APPLICATION NO: 20/01788/FUL	OFFICER: Miss Michelle Payne
DATE REGISTERED: 16th October 2020	DATE OF EXPIRY : 15th January 2021
WARD: Leckhampton	PARISH: LECKH
APPLICANT:	Miller Homes
LOCATION:	Land At Shurdington Road Cheltenham
PROPOSAL:	Full planning application for residential development comprising 350 dwellings, open space, cycleways, footpaths, landscaping, access roads and other associated infrastructure

REPRESENTATIONS

Reference 2 Environment Agency Map and Close up 94 Shurdington Road

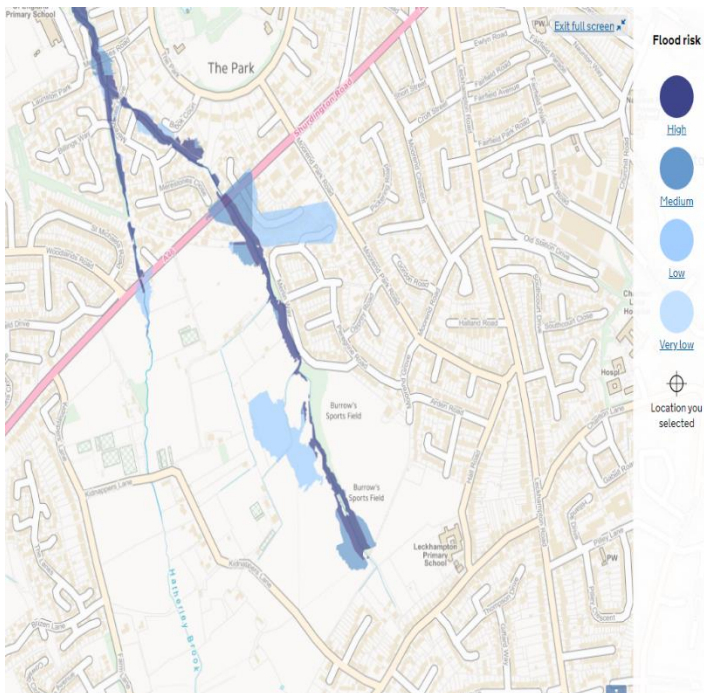
Our house is awfully close to the Zone 3 at the culvert. All of the following developments develop nearly all of the land East of the A46, land which has low permeability.

The Flooding implication of all of the following must be considered together.

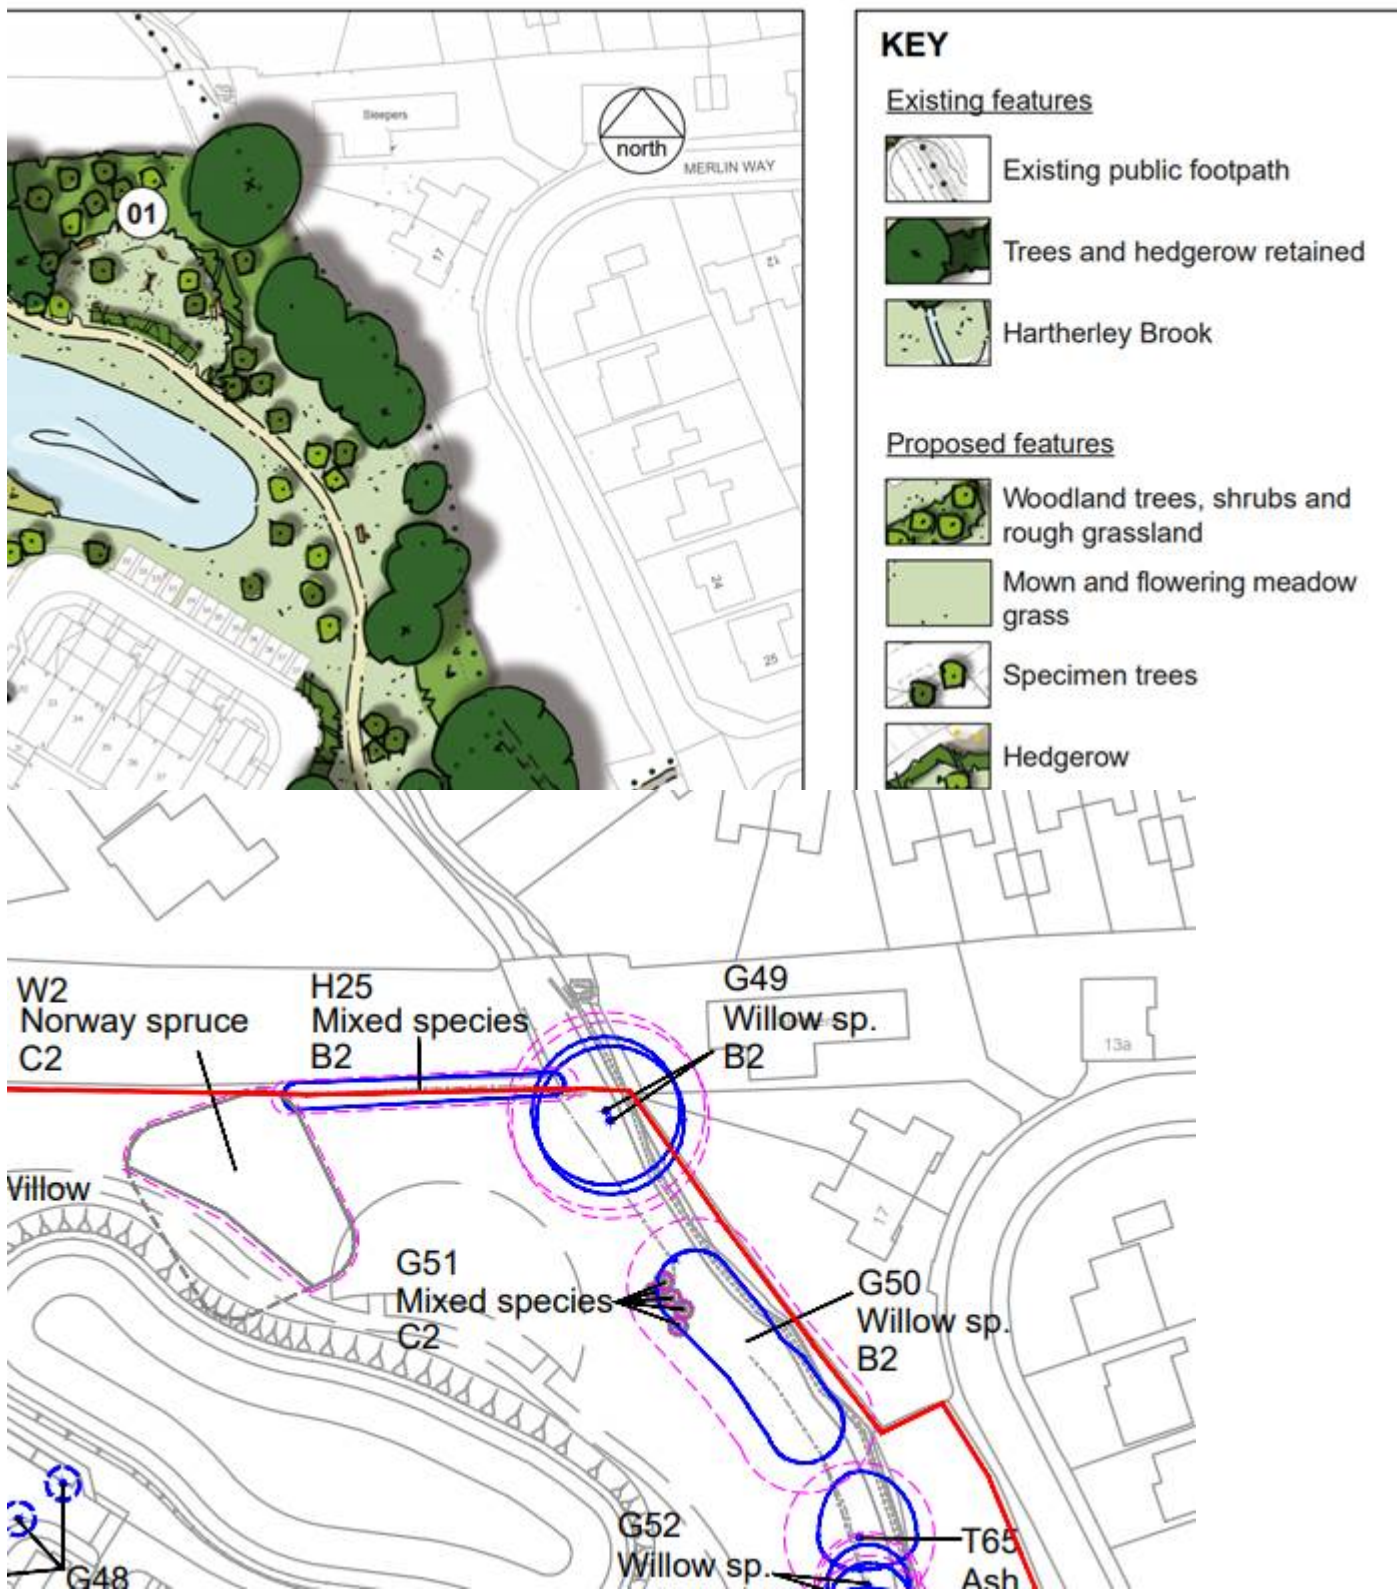
I am particularly concerned that the existing tree line could be effected along the northeast boundary. The Phase 1 Drainage Layout actually states that a tree will be removed to facilitate the proposed drainage outfall from Pond B (see extract below).

Not only do I find this unacceptable as it will significantly increase the visual impact of the proposed development from my property, it also directly conflicts with the developer's own Landscape Strategy (see extract below) and Tree Retention Plan (G49 on the extract below) that explicitly state the tree is to be retained. I would request that explicit assurances are sought from the Developer to ensure the trees along the brook are retained, as noted on their own plans, and that an alternate solution is provided for the drainage outfall that doesn't affect the existing trees.
